# 10GBase-BR40-D, +-D, -U, +-U

Proposed specs changes to IEEE802.3cp D1.1

Ray Nering  
Cisco Systems  
22 Jan 2020

# Requirements and Industry Specifications Review of 10GBASE-BR40-D

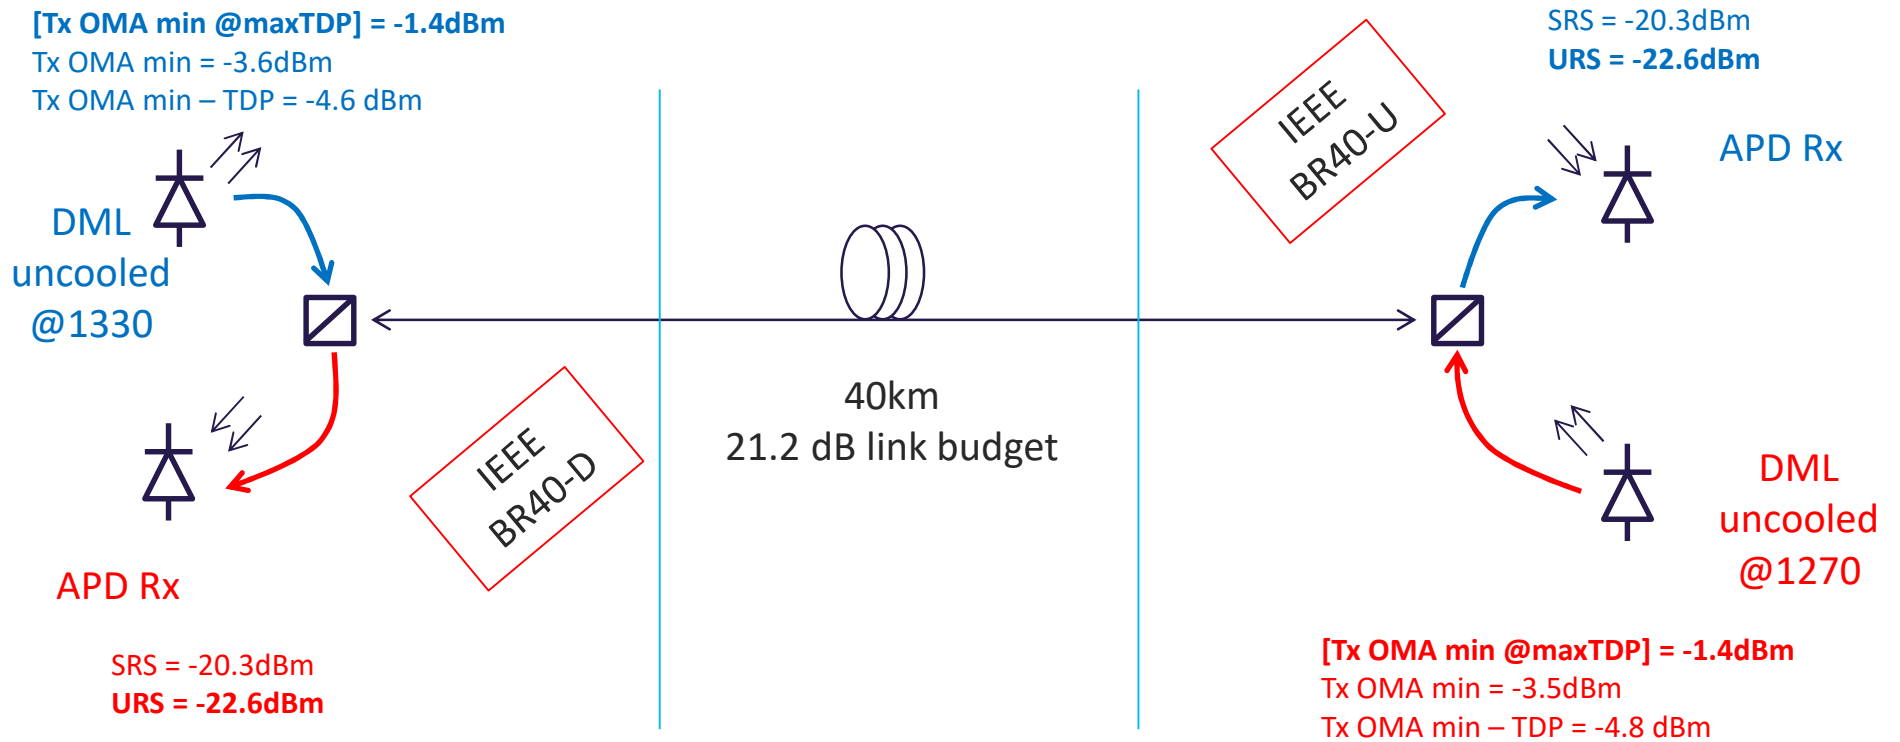
Cisco	Molex/Oplink	Huawei
10GBASE-BR40-D	Table 158-6	Proposal	TRBCXGKxEx00 0E2G	SFP-10G-ER- SM1310-BiDi
Average Launch Power (Max)	-0.6	5	5	5
Average Launch Power (Min)	-6.6	-2.7	0	0
Launch Power (Min) OMA minus TPD	-4.6	-0.5		
OMA (Min)	-3.6	0.3	0	
Tx and Dispersion Penalty	3	2.6		
Average Launch Power of Off Tx	-30	-30		
Extinction ratio	3	5.5		>3.5
		Cisco	Molex/Oplink	Huawei
10GBASE-BR-D Rx Characteristics	Table 158-8	Proposal	TRBCXGKxEx00 0E2G	SFP-10G-ER- SM1270-BiDi
Average Rx Power (Max)	-5.6	-9	-9	-9
Average Rx Power (Min)	-24.4	-21.2	-21.2	
Max Rx Power (for damage)	4	4		
Rx Sensitivity (max) in OMA	(-22.6)	-19	-19	-18
Receiver Reflectance	-26	-26	-21	
Stressed Rx Sensitivity (Max in OMA)	(-20.3)	-16.8

# Requirements and Industry Specifications Review of 10GBASE-BR40-U

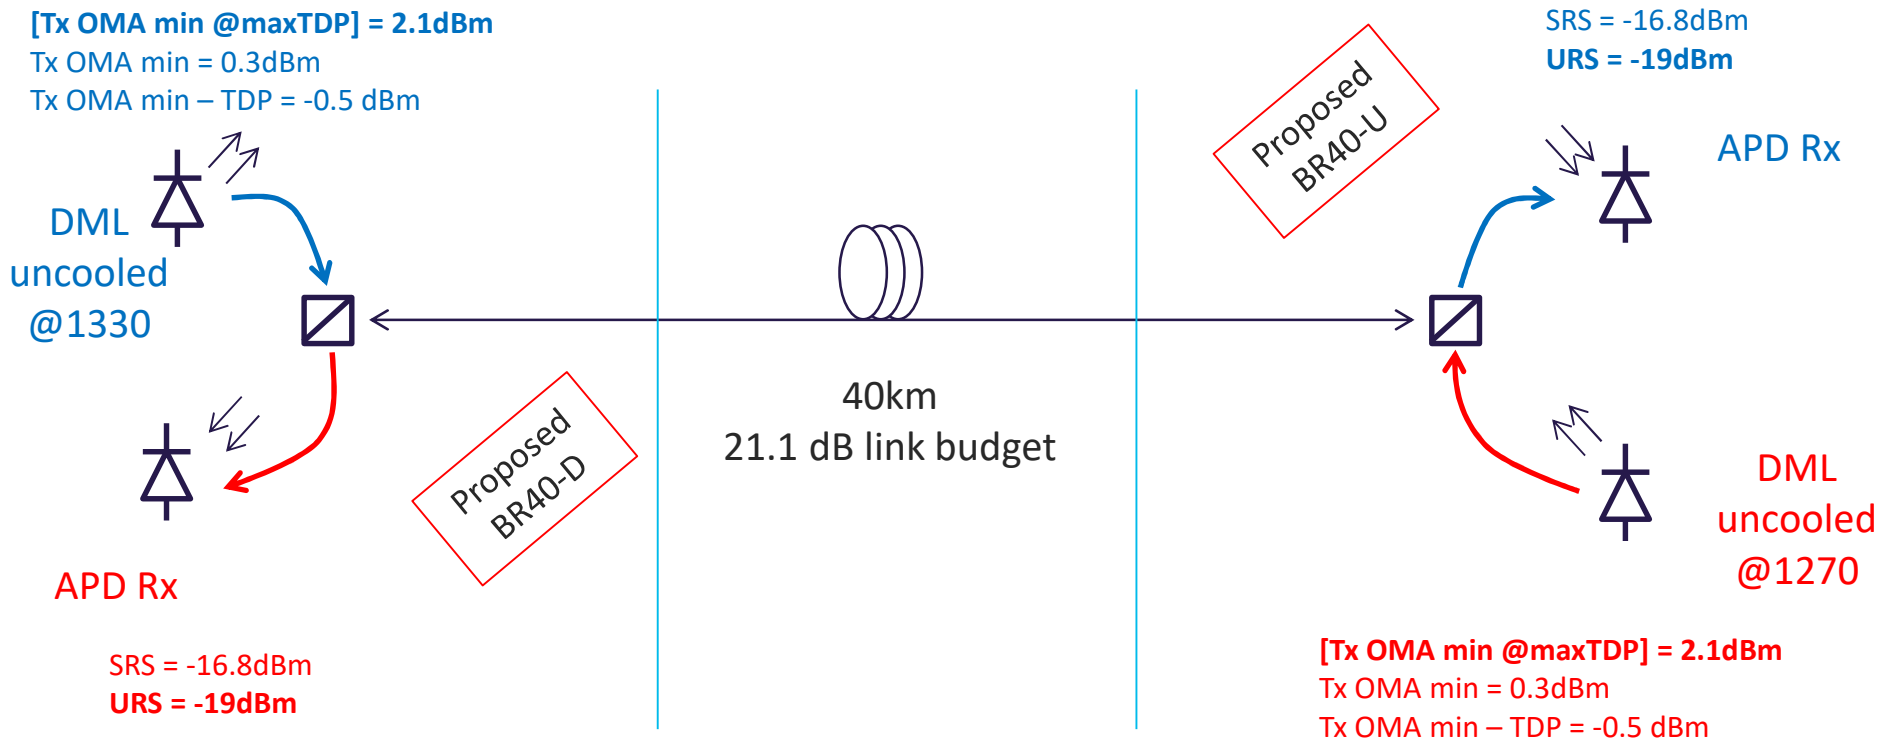
Cisco	Molex/Oplink	Huawei
10GBASE-BR40-U Tx Characteristics	Table 158-7	Proposal	TRBCXGKxEx00 0E2G	SFP-10G-ER- SM1270-BiDi
Average Launch Power (Max)	4	5	5	5
Average Launch Power (Min)	-6.4	-2.7	0	0
Launch Power (Min) OMA minus TPD	-4.8	-0.5		
OMA (Min)	-3.5	0.3	0	
Tx and Dispersion Penalty (max)	3	2.6		
Average Launch Power of Off Tx	-30	-30		
Extinction ratio	3	5.5		>3.5

Cisco	Molex/Oplink	Huawei
10GBASE-BR-U Rx Characteristics	Table 158-8	Proposal	TRBCXGKxEx00 0E2G	SFP-10G-ER- SM1270-BiDi
Average Rx Power (Max)	-10	-9	-9	-9
Average Rx Power (Min)	-24.4	-21.2	-21.2	
Max Rx Power (for damage)	4	4		
Rx Sensitivity (max) in OMA	(-22.6)	-19	-19	-18
Receiver Reflectance	-26	-26	-21	
Stressed Rx Sensitivity (Max in OMA)	(-20.3)	-16.8
